# EXHIBIT 70

**From:** David Piscuskas  
**Sent:** Sunday, August 21, 2016 11:01 PM  
**To:** David Piscuskas; Spencer Leaf; Zachary Goldstein; Heiman Luk; Fanichristina Papadopoulou  
**Cc:** Caroline Gallagher; Stephanie Chan  
**Subject:** 38/44 notes from Amy telephone meeting 8/19 / reflections / summary

38 HIGHGATE  
AMY PHONE CALL 01/14/2020

**38 Highgate Kitchen design:**

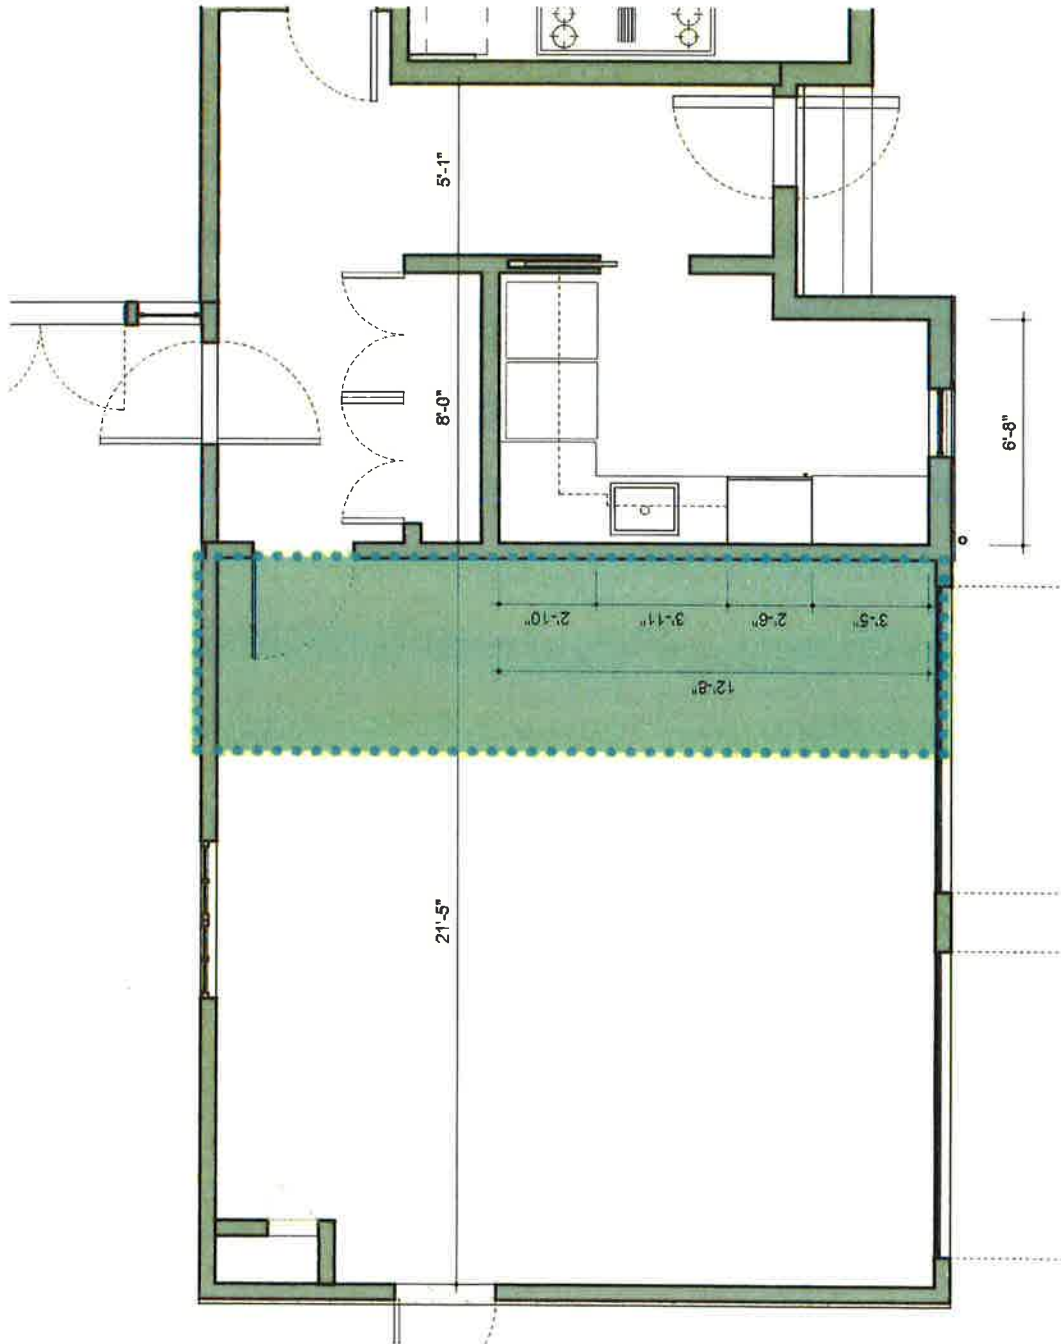
See marked up plan. She seems to be very familiar with the layout and where things live for the most part. The two issues she brought up:

- Changed her mind about wanting the microwave within the pantry closet, to be far away from sight, since they barely use it. She wants us to find another place for it, but also doesn't like undercounter microwaves. I suggested thickening up the upper cabinets, on the far west wall, but doesn't want that either.
- Changed her mind about not needing upper cabinets in the main cooking area. She needs at least two. One for spices and one for olive oil, potato chips and cereal. She probably prefers them flanking the window, because the stove wall is the first thing one sees when approaching from the hall and prefers to keep it clean.

**AMY: WHERE DO THE BARRELS GO?**

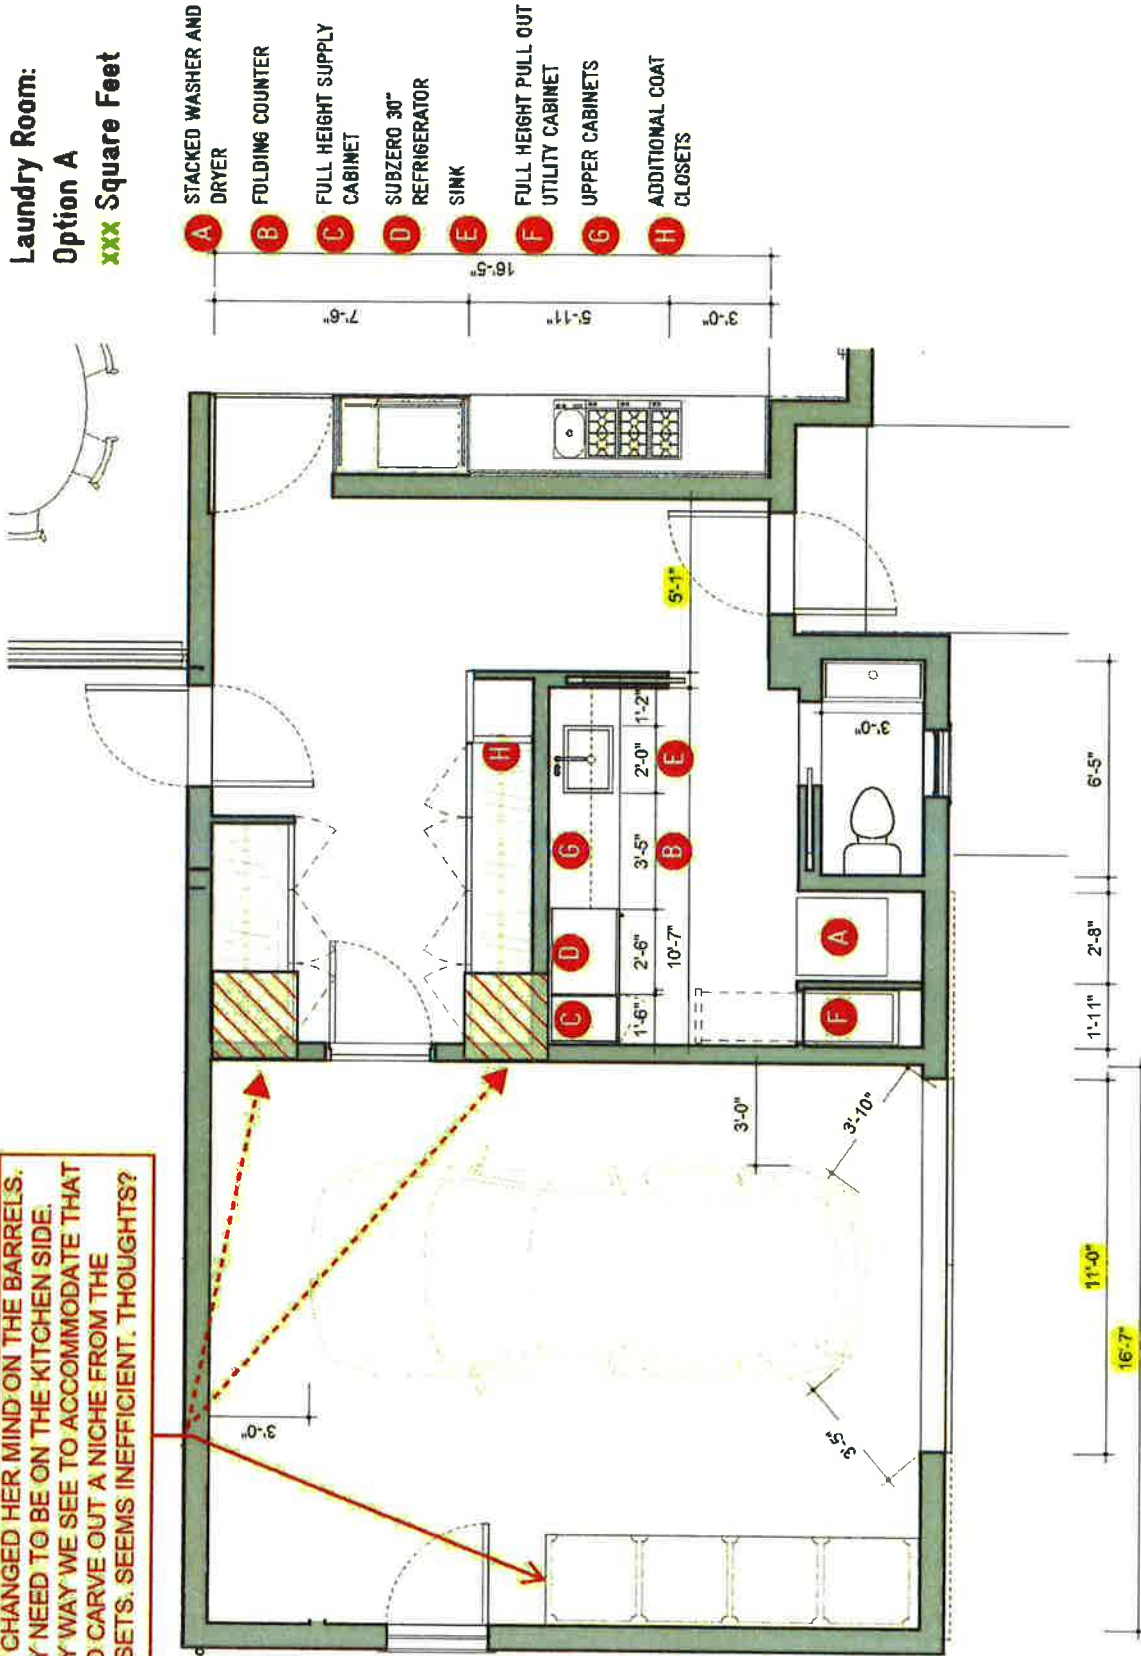
AMY CHANGED HER MIND ON THE BARRELS. THEY NEED TO BE ON THE KITCHEN SIDE. ONLY WAY WE SEE TO ACCOMMODATE THAT IS TO CARVE OUT A NICHE FROM THE CLOSETS. SEEMS INEFFICIENT. THOUGHTS?

**AMY: WHERE DOES PLASTER TRANSITION TO WOOD VENEER AT THE D.P.?**

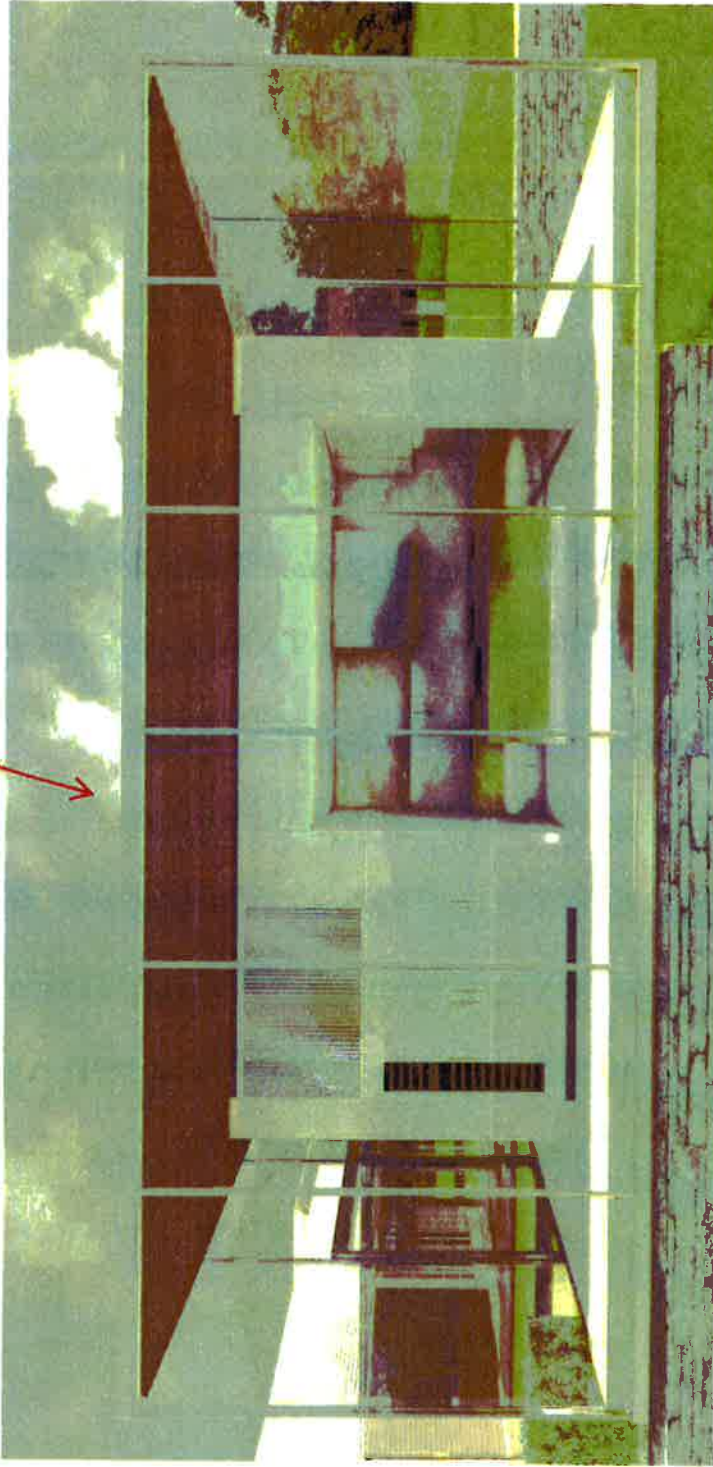
AMY HAS DECIDED THIS IS THE VIEW SHE WANTS. SHE LIKES THIS VIEW ALL WHITE. REFUSES TO ENTERTAIN ANY WOOD WRAPPING AROUND HERE

**AMY: WHERE DOES PLASTER TRANSITION TO WOOD VENEER AT THE D.P.?**

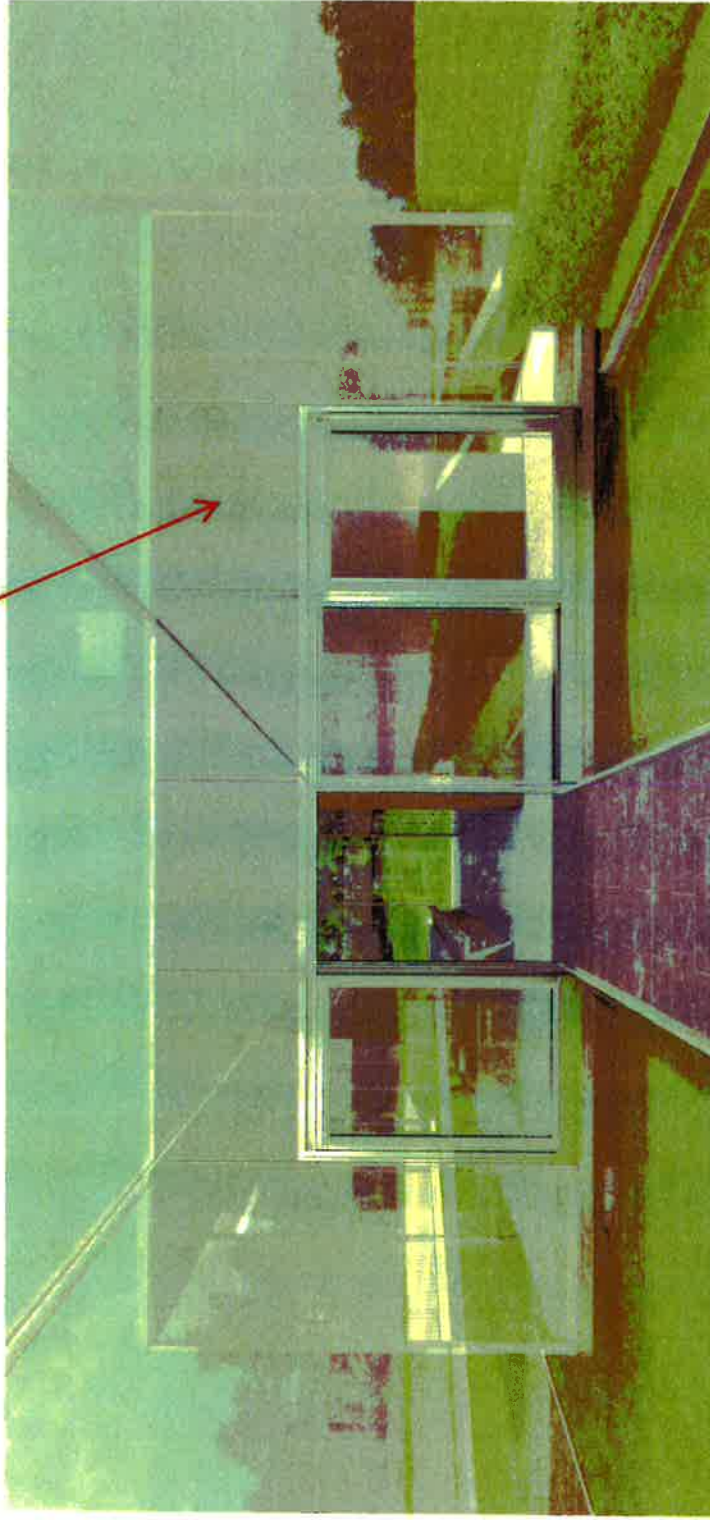
**WOULD YOU ACCEPT A REVEAL IN THIS LOCATION? TO SEPARATE PLASTER FROM WOOD VENEER?**

**AMY: KITCHEN AT 38?**

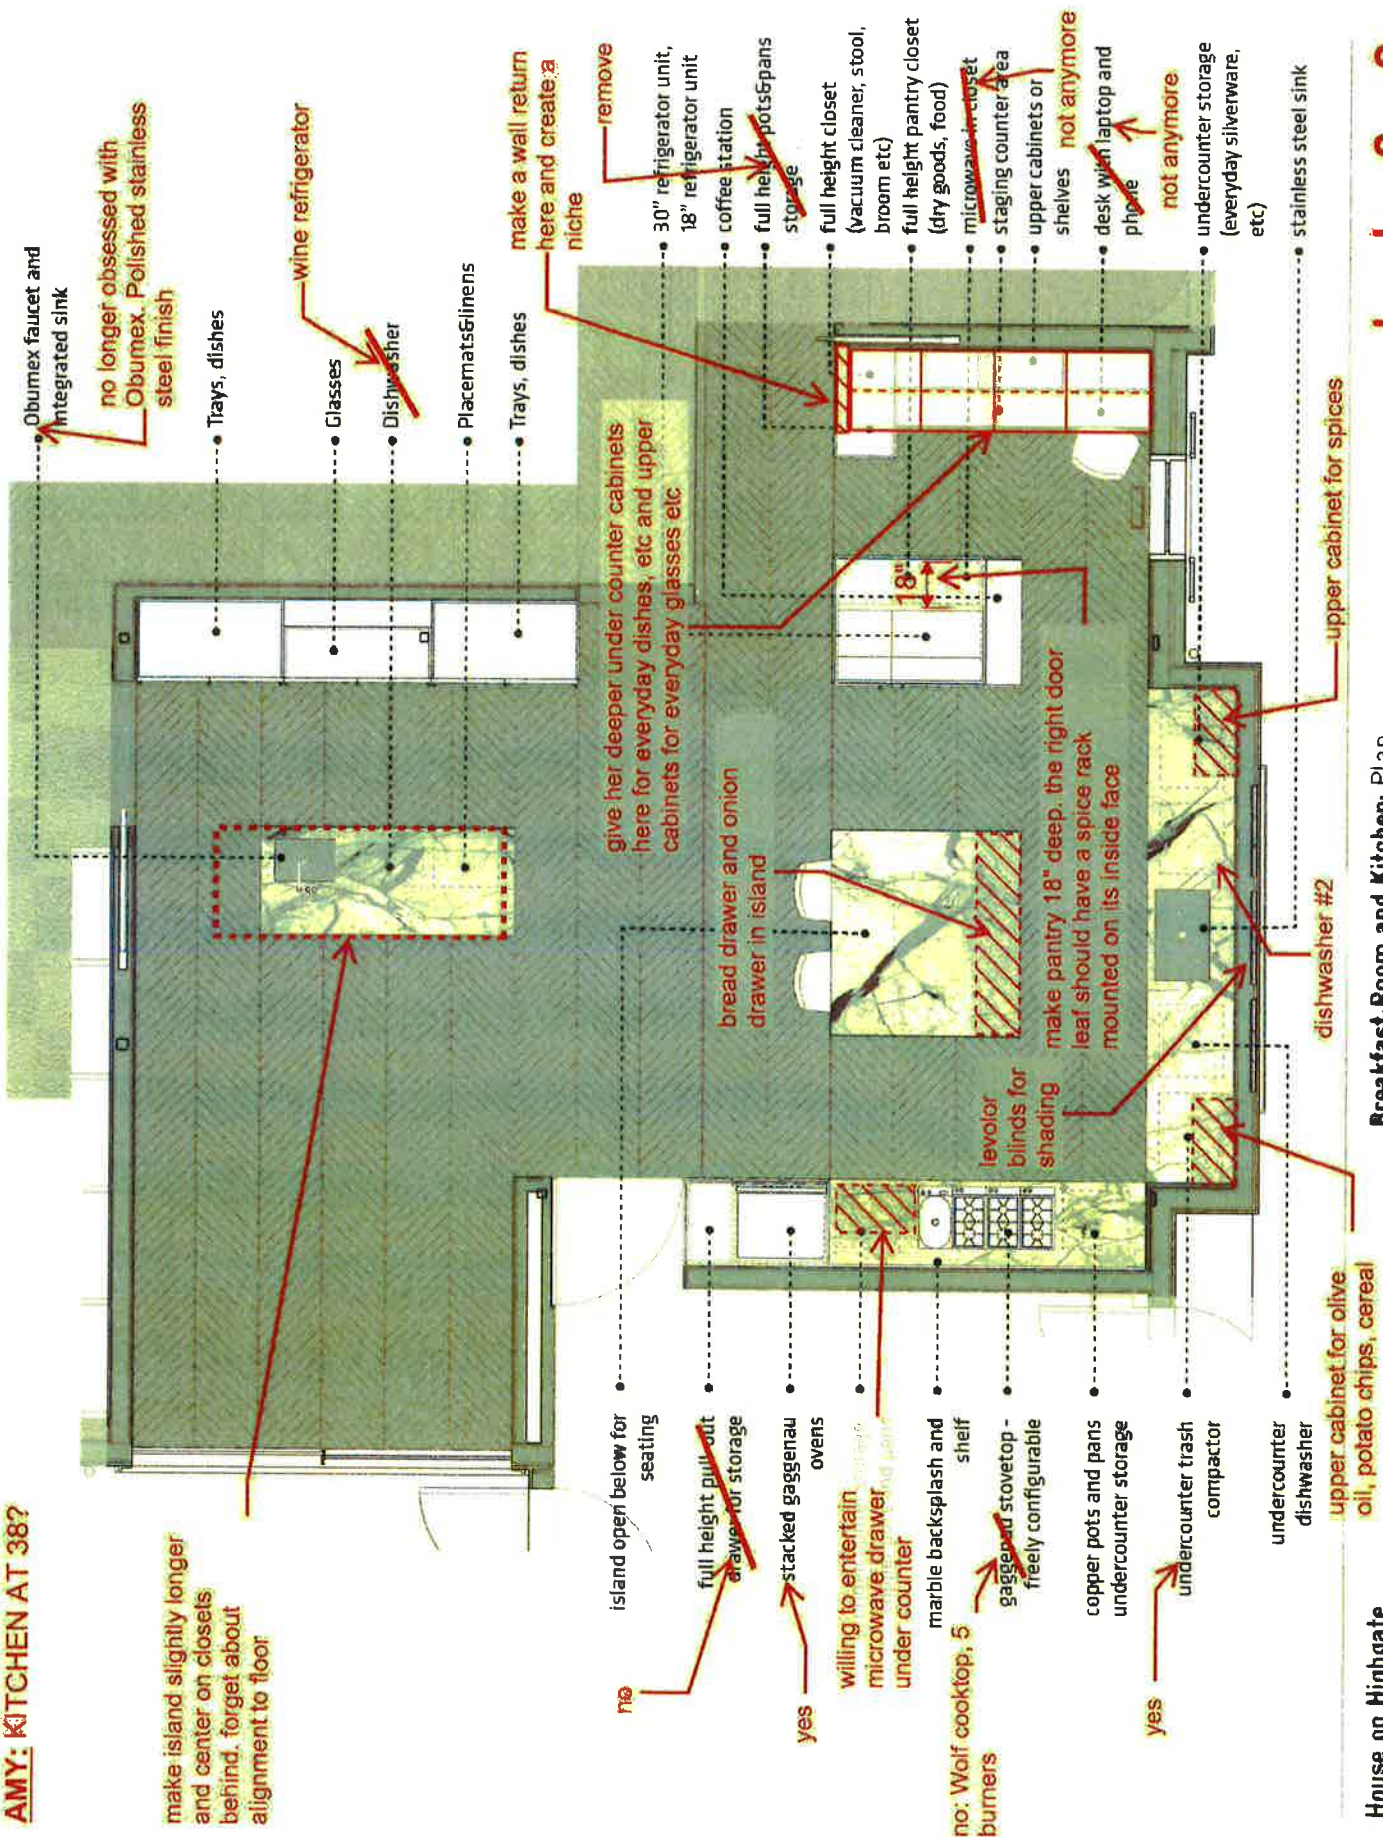
**WE HAD IT ALIGNED TO THE CHEVRON**

make island slightly longer and center on closets behind, forget about alignment to floor
